## Product Notice: OCS V2 Plug Update

Weidmuller plugs/Sockets utilised in Ampcontrol OCS V2 systems have been made obsolete by the manufacturer.

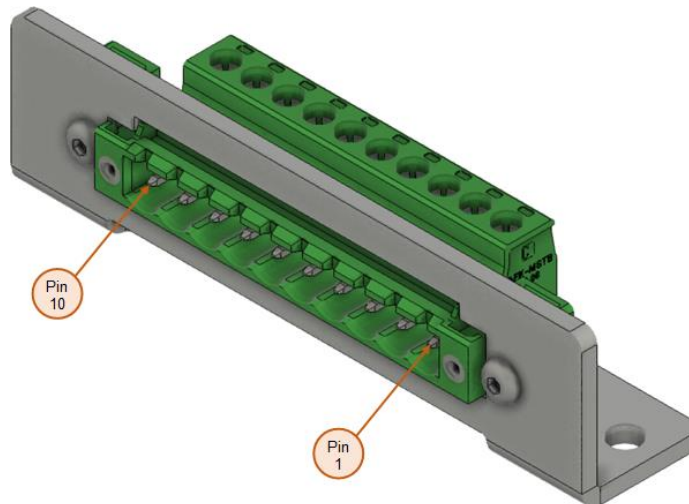
New Cassettes will be supplied with a plug for retrofit into the Chassis. Wiring remains the same with pin assignment as per the below image
